Technical Service Bulletin

NUMBER: 23-50-99

Instrument Panel Creak

2000 (PL) Neon

FIGURE 1

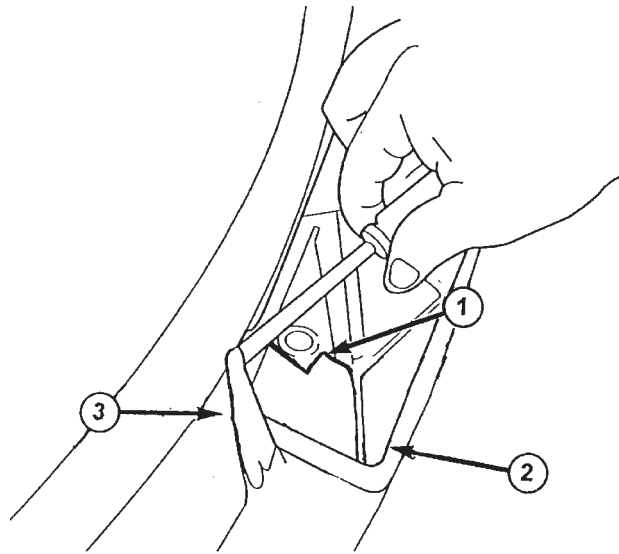
1. Remove the windshield wiper arms following the procedure in the 2000 Neon Service Manual (Publication No. 81-270-0025) page 8K-5.
2. Remove the cowl screen cover following the procedure in the 2000 Neon Service Manual (Publication No. 81-270-0025) page 23-27.
3. Using Figure 1 as a reference, locate the area of the cowl reinforcement panel to be modified. Remove the excess sealer to allow access as needed. A mirror positioned to show the underside of the cowl top will help in locating the contact areas.
4. Use a screwdriver and bend the top of the cowl reinforcement panel down and away from the cowl top panel. A minimum clearance of 2.0 mm (.078 inch) should be obtained between the two panels (Figure 2).
